XDiavel S Rear Wheel  
Models: Model Year 2016 XDiavel S (all country versions)  
Recall Bulletin SRV-RCL-16-001

Date: June 7, 2016  
To: Dealer Principal, General Manager, Service Manager, North American Dealer Network  
From: Richard Kenton, Technical Director; Jonathan LaForte, Technical Manager

NHTSA Campaign I.D. Number: 16V370  
Transport Canada Safety Recall I.D. Number: 2016-258

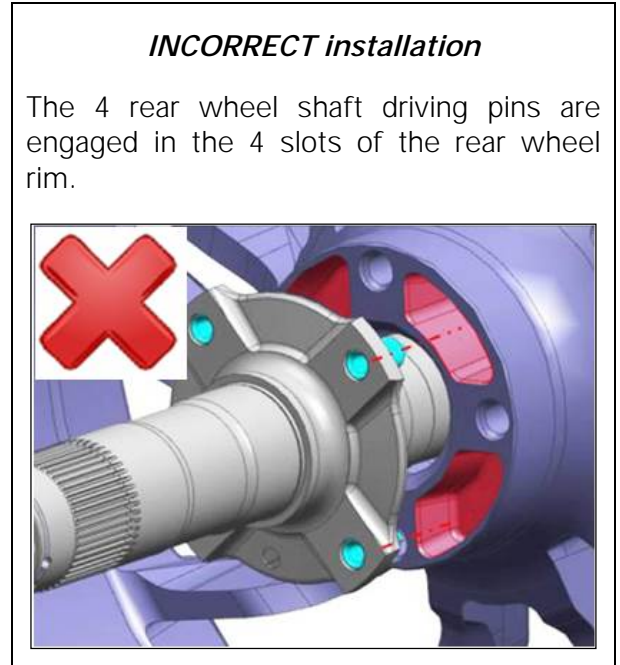
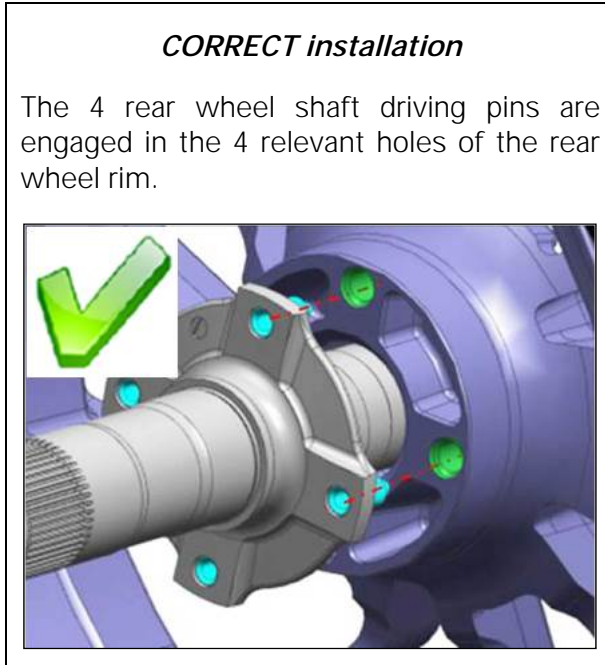
If the installation is incorrect, you must replace the rear wheel rim before going on with step (b). The rear wheel rim must be replaced because when the installation is incorrect, i.e. with the 4 rear wheel shaft driving pins engaged in the 4 slots of rear wheel rim, the 4 pins damage the rim hub and cause grooves and marks (as shown in the figures below):

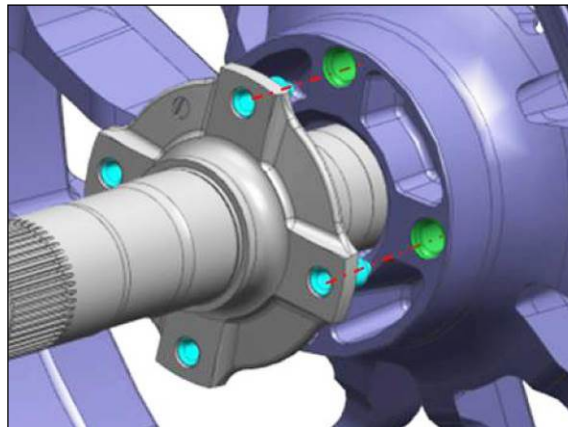
- 3) Fit the 4 error-proof inserts in the slots on rim aiming them with the concave side facing out and the convex side towards the rim. Bring inserts fully home in the slots, until plug outer surface is deeper than rim profile.

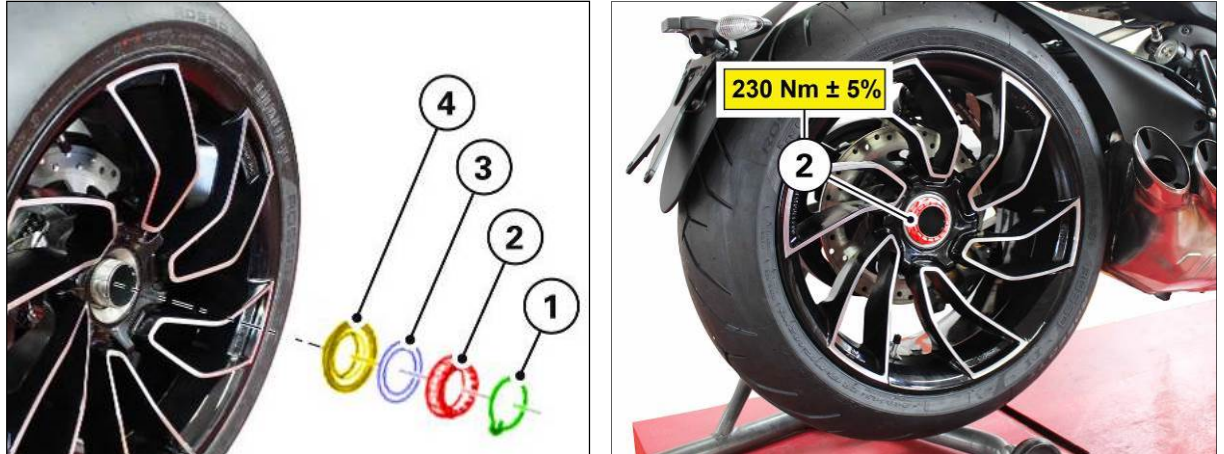
Install **spacer (4)** with its tapered surface facing the rear wheel and the **washer (3)** as shown in the figure.

Tighten the **nut (2)** to **230 Nm  $\pm$ 5%** making sure that the hole on nut is aligned with one of those on wheel shaft and then install the **retainer (1)** by engaging its end into one of the holes on the shaft.
